# CTI <sup>Service</sup> Bulletin #1

## STEER AXLE MODIFICATIONS

This is the first in a series of CTI Service and Operation Bulletins prepared by SDTDC, in cooperation with Eaton Corporation, to provide assistance in maintenance, repair and operation of the Eaton Tire Pressure Control System (TPCS).

Figure 2

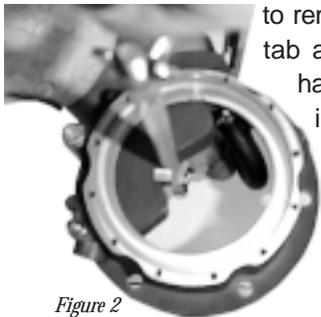
The rotary joint drive tab (figure 1) can be removed by milling or, as shown in figure 2, by using a hacksaw to remove the bulk of the tab and finishing with a half-round file. It is not important to remove the small section of the tab which extends outboard of the wheel valve cavity.

Figure 1

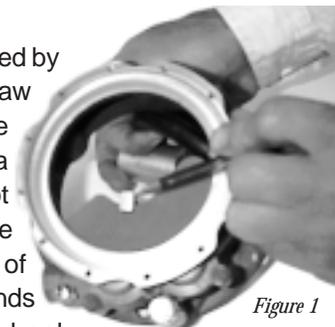
All versions of Eaton's steer axle CTI hardware have experienced some problems due to runout between the rotary joint and hub cap. Runout and interference can impart side loads to the rotary joint which greatly reduce its service life.

Use the modification procedure described below to eliminate the steer axle problem and extend the life of the rotary joints. Figure 1 shows the location of the rotary joint driver tab.
